CITY OF ST. PETERSBURG, FLORIDA
PLANNING AND DEVELOPMENT SERVICES DEPARTMENT
URBAN PLANNING AND HISTORIC PRESERVATION DIVISION

Community Planning and Preservation Commission
Certificate of Appropriateness Request

CITY FILE NO.: 21-90200008

After-the-Fact COA. Request for approval of as-built conditions relating to new construction at 736-18th Avenue NE. The as-built conditions deviate from several conditions of approval, for which the applicant is now requesting a modification or compliance waiver.

FRONT ELEVATION
SCALE 1/8"=1'-0"

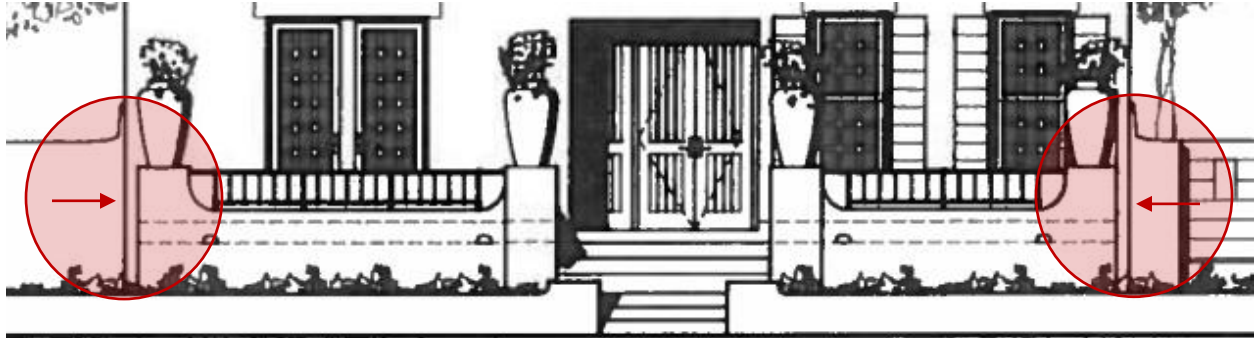
The red arrows show a break line delineating the main house from the recessed wall, consistent with the submitted (and now approved) site plan and color rendering.

Appendices, Page 12 and 13 of 52:

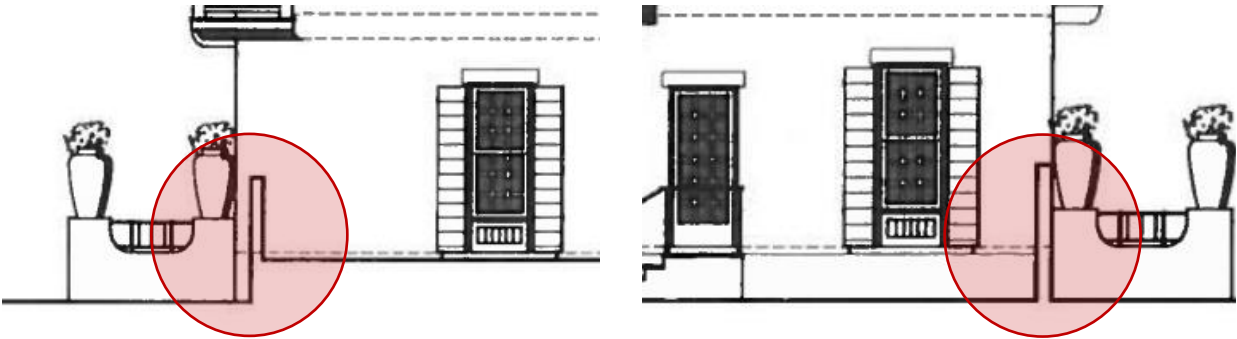
The applicant has rightfully pointed out that the wall location on this plan drawing (east elevation) is flush with the front plane of the house, but continues to be refuted by the associated reports and all other plans in the permit set as highlighted in this memorandum.

Color Rendering:

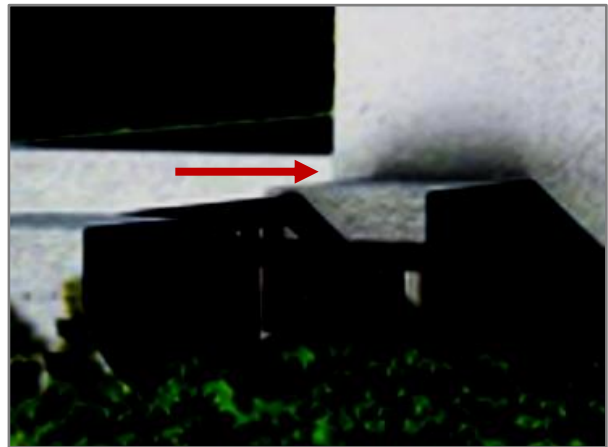
In addition to the elevations, the color rendering submitted with this COA application includes shading to appropriately delineate between the front plane of the house and the recessed wall.

Cropped color elevation.

Cropped color elevation with adjusted brightness (-40%) and contrast levels (75%) to show hard shade line at corner.

Sheet A3 Rear and Left Elevation:

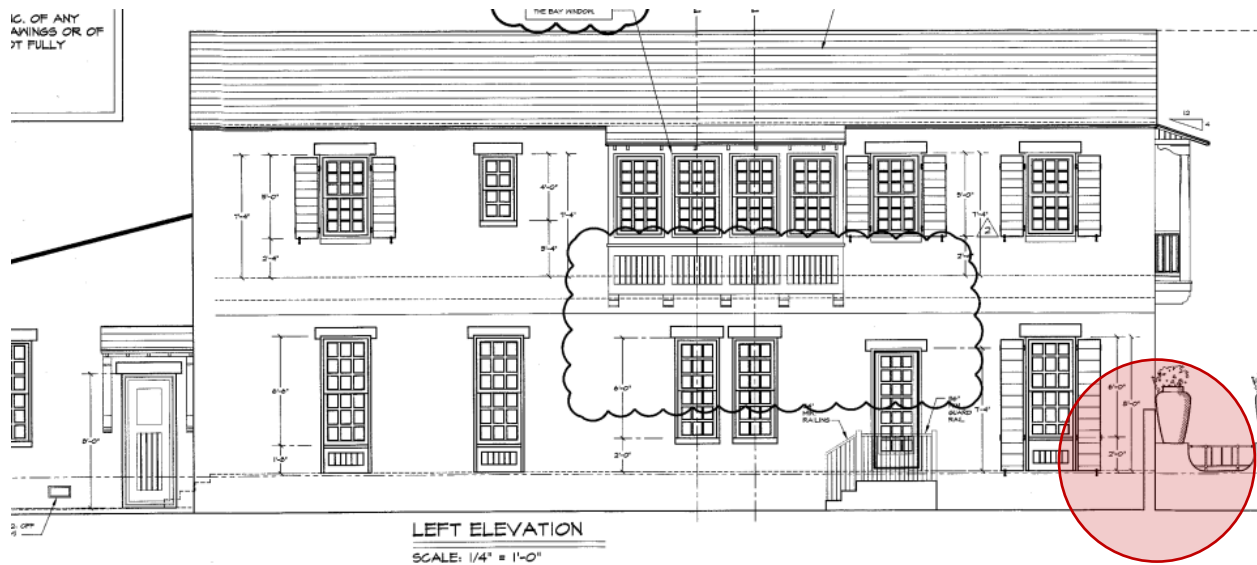
As noted earlier, this plan drawing (east elevation) is flush with the front plane, but continues to be refuted by the associated reports and all other plans in the permit set as highlighted in this memorandum.

Revision Memorandum
Prepared by Derek Kilborn
Dated October 24, 2019

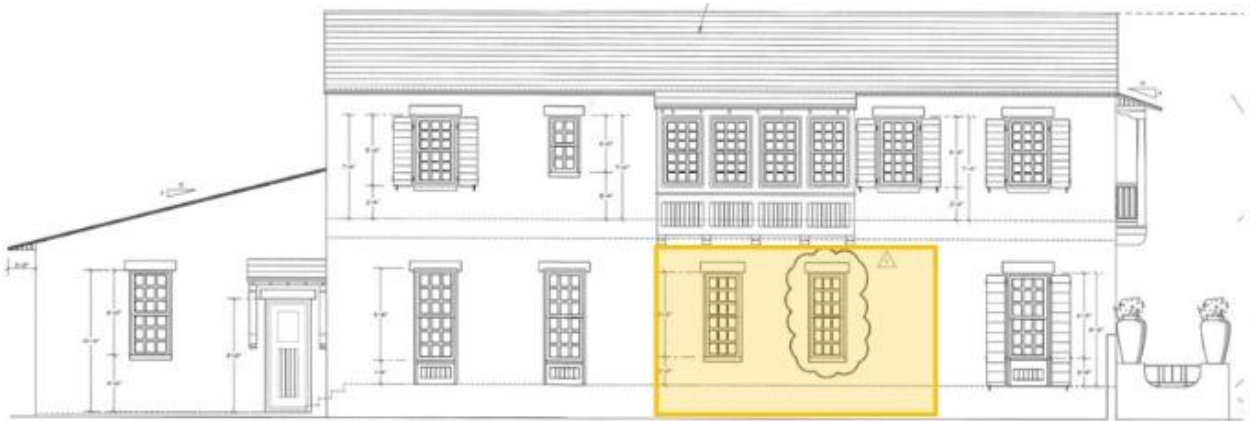
On October 19, 2018, historic preservation staff provided plan review comments on NSFR permit application 18-08001081, noting that the fenestration at the building's east elevation did not match the application which had been approved by the CPPC, upheld by City Council, and then challenged in Court by an immediate neighbor.

The inconsistency of the fenestration at the east elevation was determined to constitute a substantial design change from the plans as submitted during the COA application. City staff concluded that the proposed change from the originally approved plans created a misalignment between first- and second-floor openings that detracted from the overall rhythm required by the subject property's proposed Monterey-inspired design. The plan review was returned to the applicant for correction accordingly.

Under a later resubmission, the proposed fenestration at the east elevation was shown to have reverted to the original design approved under COA 18-90200016. City staff approved this change on September 13, 2019. Finally, on October 22, 2019, the applicant submitted another request to revise the fenestration at the east elevation, which was administratively approved by City staff and further described in a *Revision Memorandum* dated October 24, 2019.

Submitted to permitting on October 23, 2019

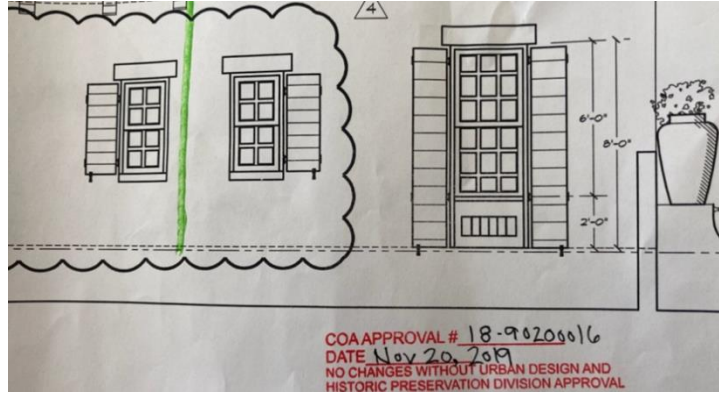
As noted by the applicant, this plan drawing (east elevation) is flush with the front plane of the house, but continues to be refuted by the associated reports and all other plans in the permit set as highlighted in this memorandum. The revision and approval stamp in the example below was for the plan change inside the bubble.

**Email from Richard McGinnis to Laura Duvekot
Dated March 27, 2020**

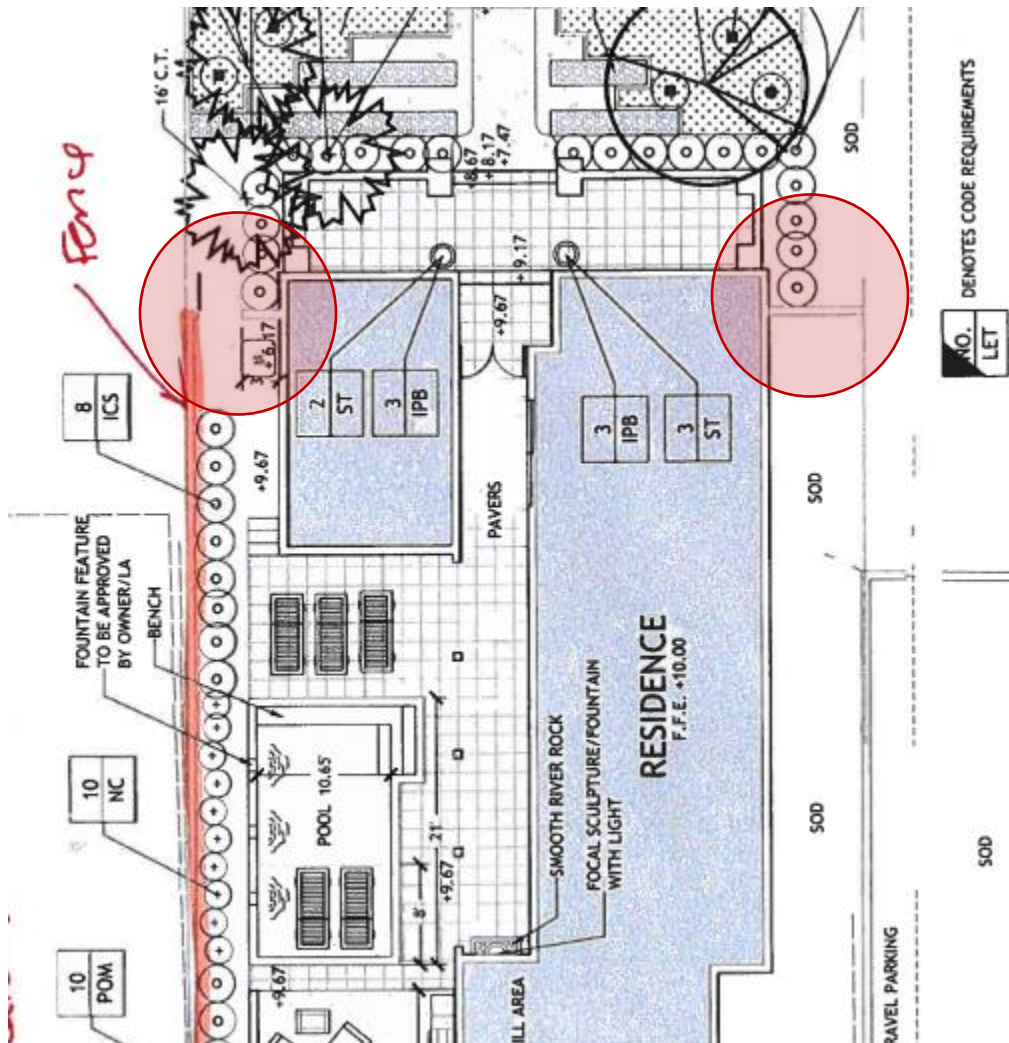
Perhaps the most significant evidence relating to the wall off-set and gate is a document emailed from the applicant to our Division as *recently* as March 27, 2020. The email attachment clearly shows the approved wall locations with a gate and wall off-set from the front plane of the house.
